MEMORANDUM

REVIEW TYPE: Revision to Preliminary Plan Conditions

PROJECT NAME: 5420 Edson Lane (Higgins Estate)

CASE #: 11996015A (1-96015A)

ATTACHMENT B

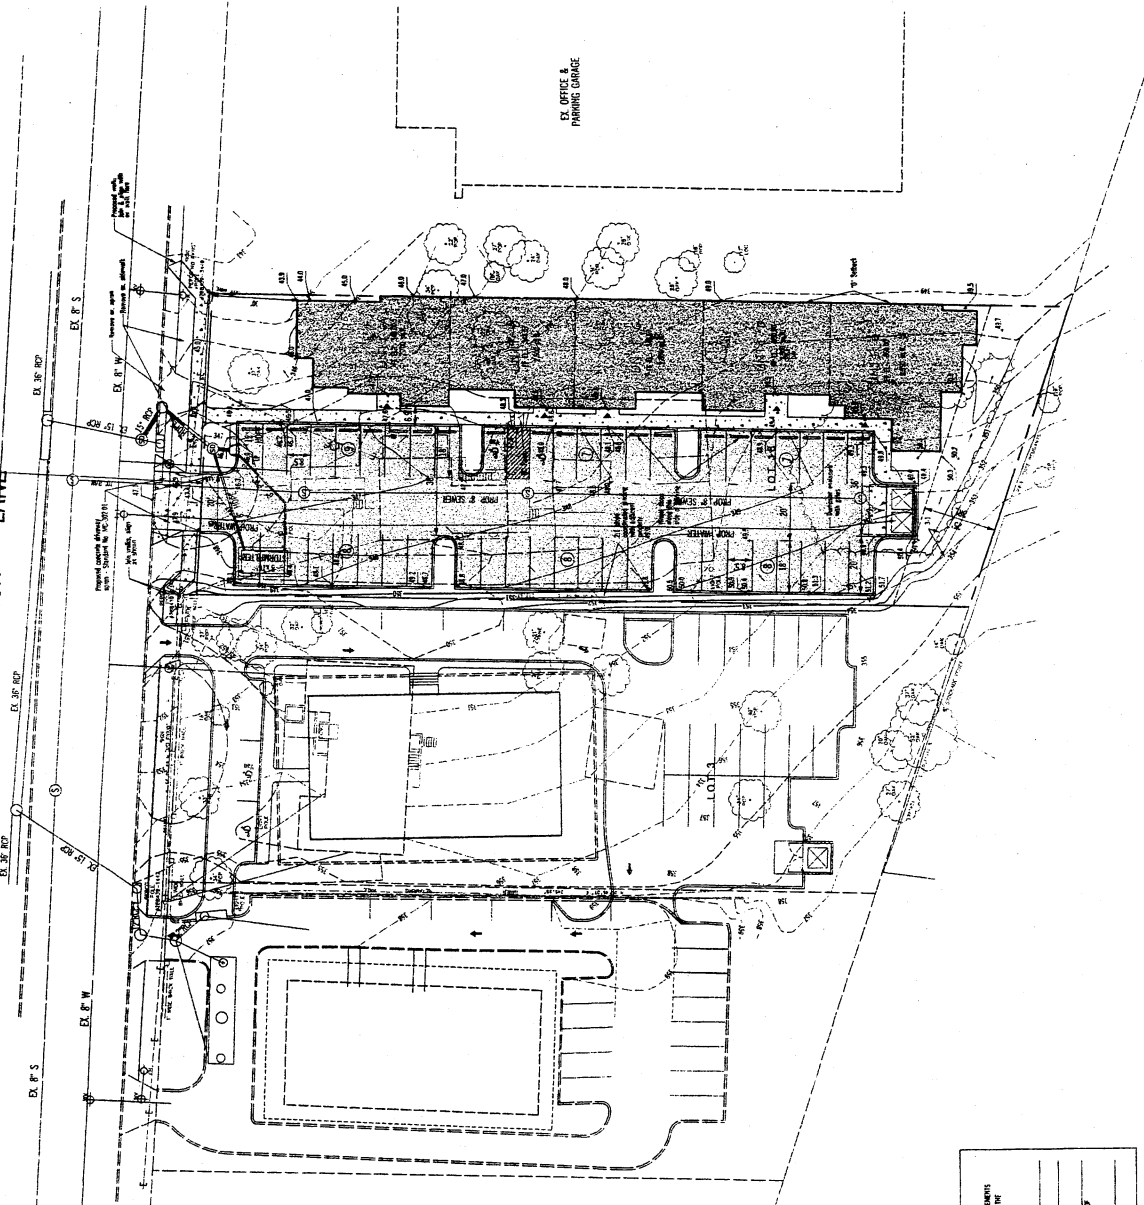
The application requests approval for a 13,150 square foot townhouse office building under a condominium regime on a single lot. (Attachment B) The building will be located on the eastern portion of the rectangularly shaped lot. Access to the site is via a driveway from Edson Lane that leads into a 47 space parking lot. The building is proposed to be two stories and must not exceed the 35 foot height limitation in the C-T zone.

The subject site is located on the south side of Edson Lane between Rockville Pike (MD 355) and Woodglen Drive. The two existing curb cuts into the U-shaped driveway from Edson Lane are to be replaced by a new access point into the parking area along the western side of Lot 18.

Pedestrian facilities would not be adversely impacted by the proposed redevelopment. A five-foot-wide sidewalk exists along Edson Lane, while the applicant plan shows a five-foot-wide lead-in sidewalk from Edson Lane to the main entrance. Bicycle racks are required as described in Condition #7 above.

- 1) Approval under this preliminary plan is limited to a maximum of 13,150 square feet of general office space.
- 2) Prior to release of building permits, the applicant shall fully execute a Traffic Mitigation Agreement with MCDPWT and the Planning Board to participate in the North Bethesda Transportation Management Organization.

- 7) Show location of bike lockers or approved bike racks at the time of site plan.
- 8) Final approval of the location of building, on-site parking, site circulation and sidewalks will be determined at site plan.
